DUKE POWER COMPANY OCONEE NUCLEAR STATION

PROPOSED TECHNICAL SPECIFICATIONS

Remove Page	Insert Page	
vii	vii	
2.1-1	2.1-1	
2.1-2	2.1-2	
2.1-4	2.1-4	
2.1-5	2.1-5	
6.9-1	6.9-1

Variable Low Pressure

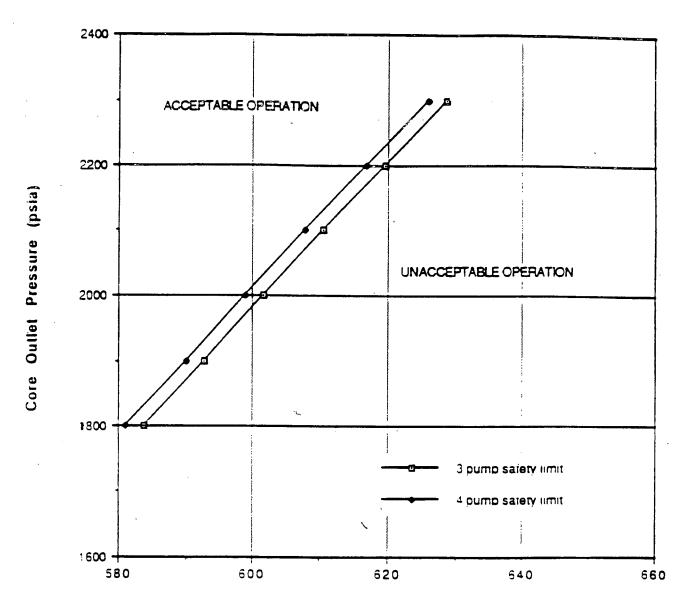
The curve presented in Figure 2.1-1 represents the conditions at which the minimum allowable DNBR is predicted to occur for the limiting combination of thermal power and number of operating reactor coolant pumps. This curve is based upon the design nuclear peaking factors provided in the Core Operating Limits Report.

Axial Power

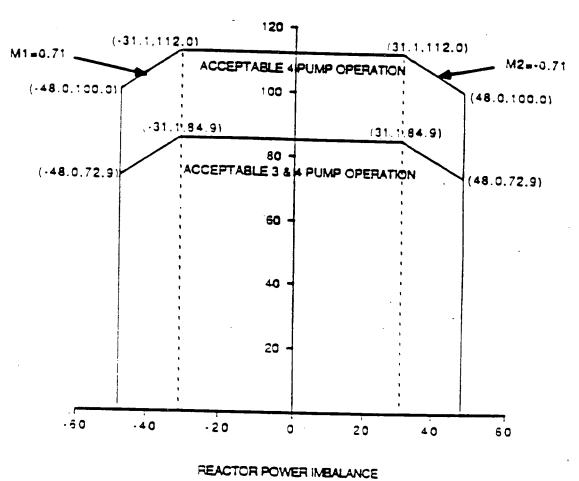
Since power peaking is not a directly measurable quantity, DNBR limited power peaks and fuel melt limited power peaks are separately correlated to measurable reactor power and power imbalance. The reactor power imbalance limits, Figure 2.1-2, define the values of reactor power as a function of axial imbalance that correspond to the more restrictive of two thermal limits - MDNBR equal to the DNBR limit or the linear heat rate equal to the centerline fuel melt limit.

The core protection safety limits are based on an RCS flow less than or equal to 385,440 gpm (4 pump operation). Three pump operation is analyzed assuming 74.7 percent of four pump flow. The maximum thermal power for three pump operation is provided in Figure 2.1-2.
